SUBJECT: Forwards data & seven oversize drawings for structural analyses of Unit 1, in response to BNL request. Modeling parameters for Unit 2 containment interior structure also encl. Aperture cards are available in PDR.

Re: Docket No. 50-275
Docket No. 50-323
Diablo Canyon Units 1 and 2

Subject: Diablo Canyon Containment

MATHEMATICAL MODEL FOR VERTICAL ANALYSIS OF INTERIOR STRUCTURE

FIGURE A-1

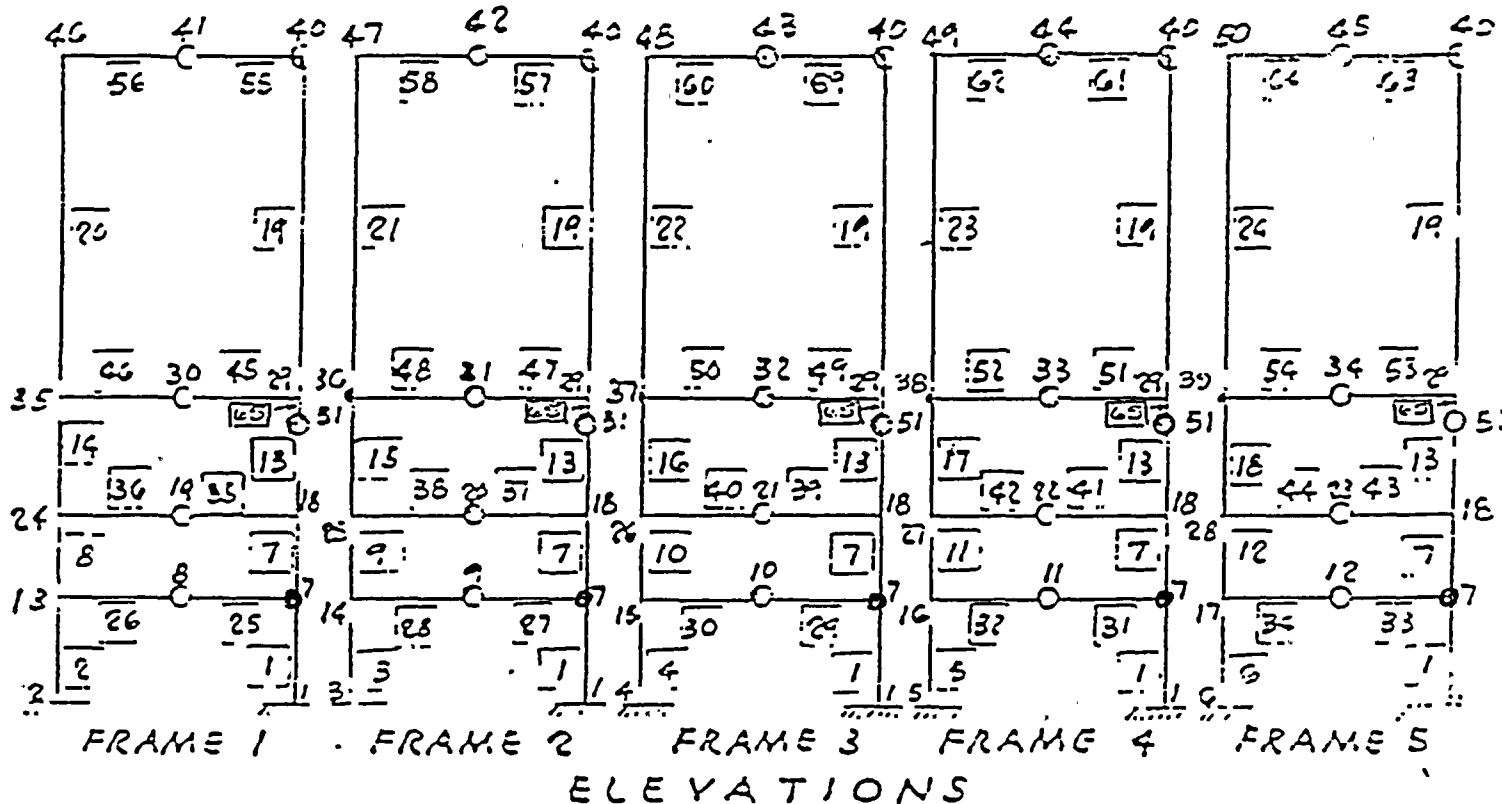
One (1) copy of modeling parameters for the 1977 model of the Containment Interior Structure. This information was previously transmitted on October 16, 1981, and has been updated to reflect recent changes in the section properties and masses of the multi-mass model of the concrete interior structure.

Revised
3-10-82

Section properties 3-29 revised for current steel drawings
Revised properties not shown

CORRECTED
MASSES

Masses for steel (annulus) nodes revised for 10/30/81 pgt. loads
Revised steel masses not shown.
